## ARBORIST REPORT

Tree Inventory, Tree Descriptions and Recommendations Relative to Proposed Construction

### Winchester Boulevard Office

Winchester Boulevard at Shelburne Way, Los Gatos

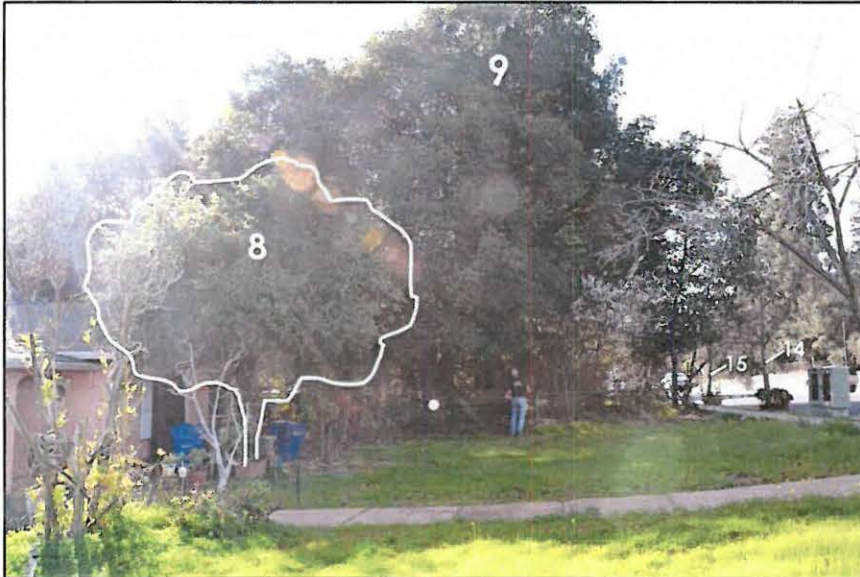
This is a partial side-view of **coast live oaks #2 and 3** from the southwest. Imagine a 2-story building 12 feet from the trunks of these trees, which tucked well inside the canopy. Now imagine trying to construct the 2-story building without having to cut off all the branches on the building side of the trunk. Such pruning will be necessary if the building is constructed as shown on the plan I reviewed. This photo was taken April 9, 2012 so the trees have probably grown a bit larger since then.

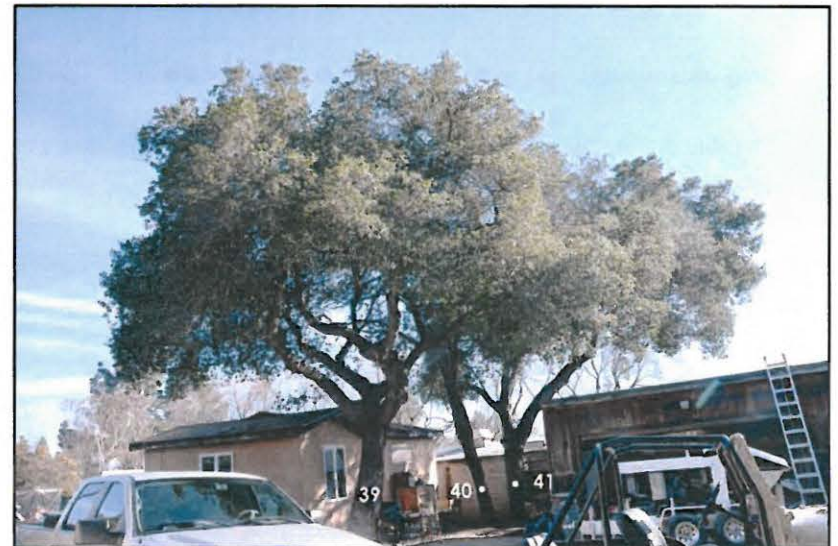
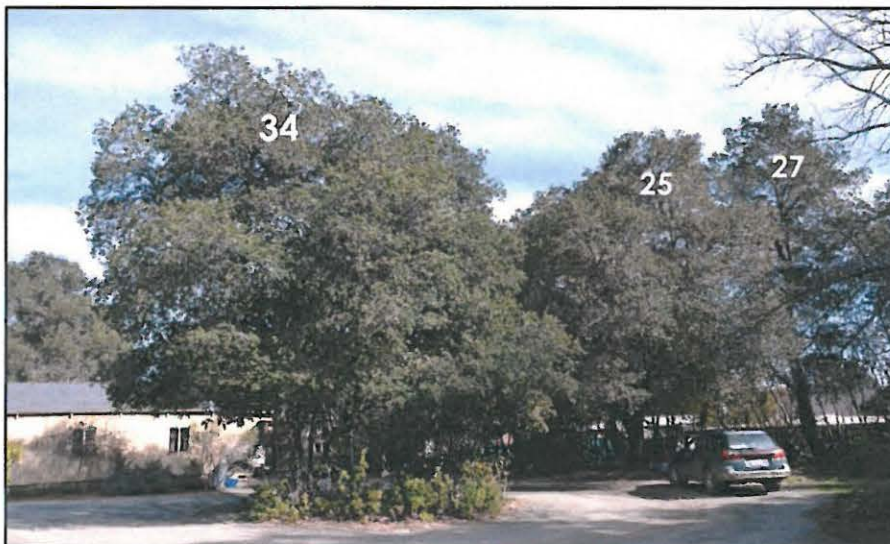
Upper Left: **coast live oak #8** (foreground) with large coast live oak #9 in the background. Winchester Blvd. to the right.

Lower Left: **coast live oaks #12 and 16**. Winchester Blvd. to the left.

Right: **coast live oaks #17 and 18**. Winchester Blvd. is toward the foreground.
